Subject: Safety Recall 05V-266
(Ford Number 05S33)

SUBJECT: DEMONSTRATION / DELIVERY HOLD: Safety Recall 05S33:
Certain 2005 Model Year F-250/350/450/550 Super Duty Trucks Equipped With 5.4L
and 6.8L Gasoline Engines
Fuel Line Retainer Clip Installation

FIGURE 1

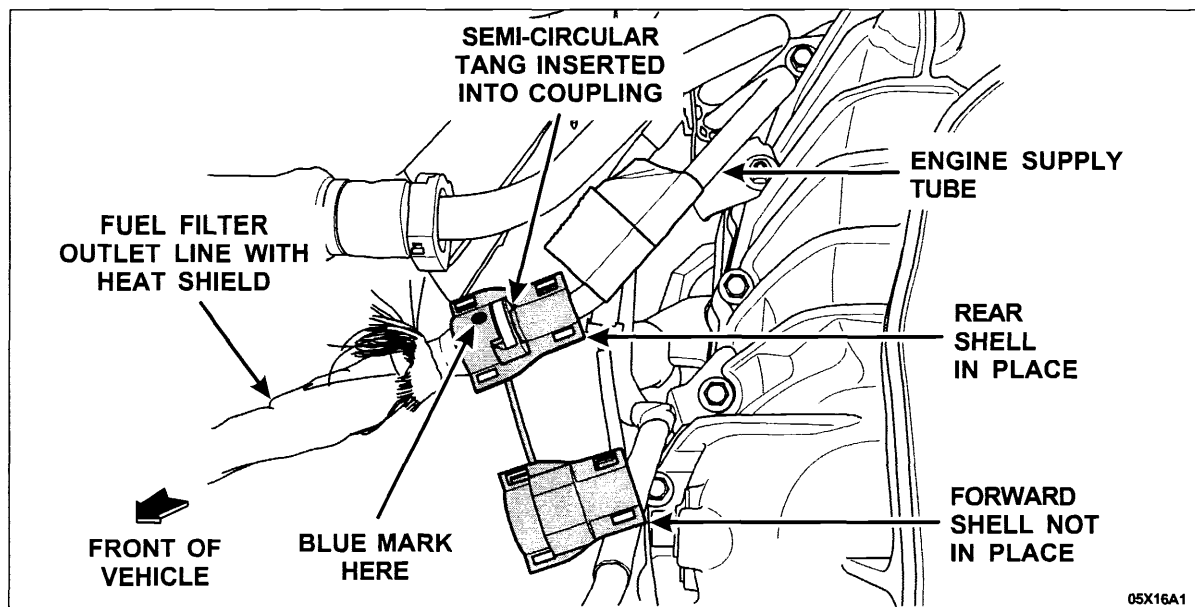
- a) Push together the fuel lines to make sure they are fully engaged.
- b) Position the rear shell with BLUE mark over the blue release button and with the semi-circular tang inserted into the coupling. See Figure 1.

FIGURE 2

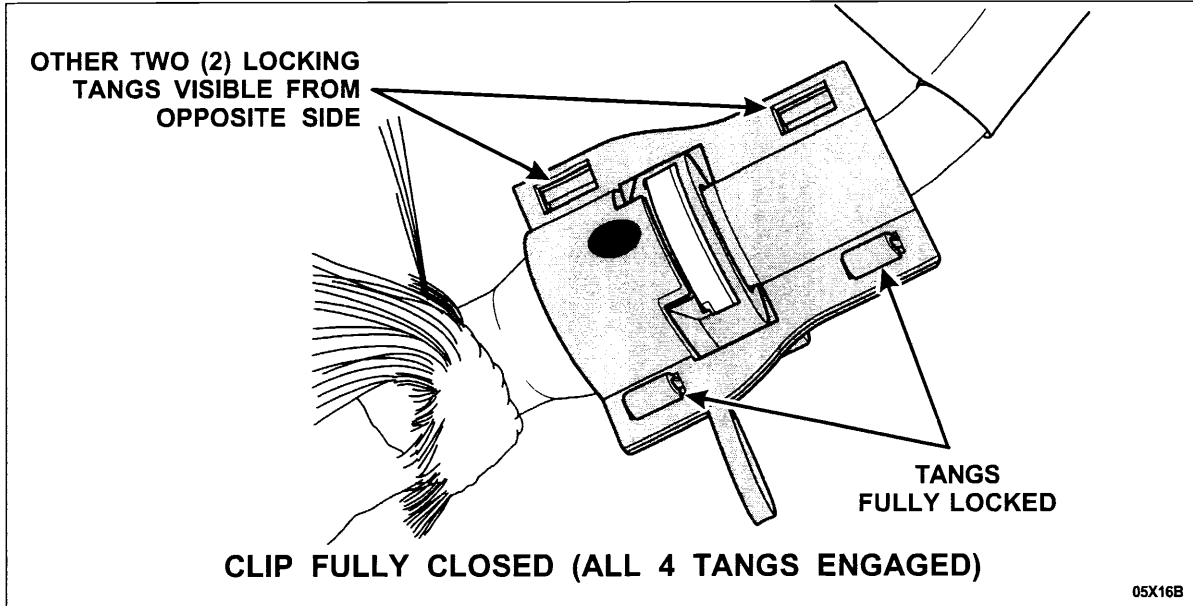
- c) Position the forward shell around the front of the coupling and engage all four (4) locking tangs.
See Figure 2.

FIGURE 3

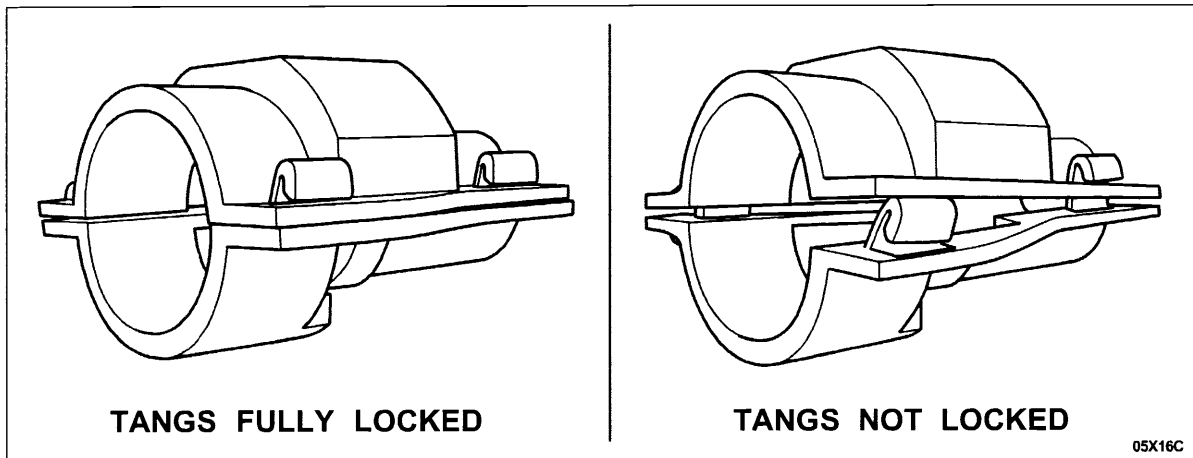
- d) Visually inspect all four (4) tangs to make sure that they are properly engaged. See Figure 3.
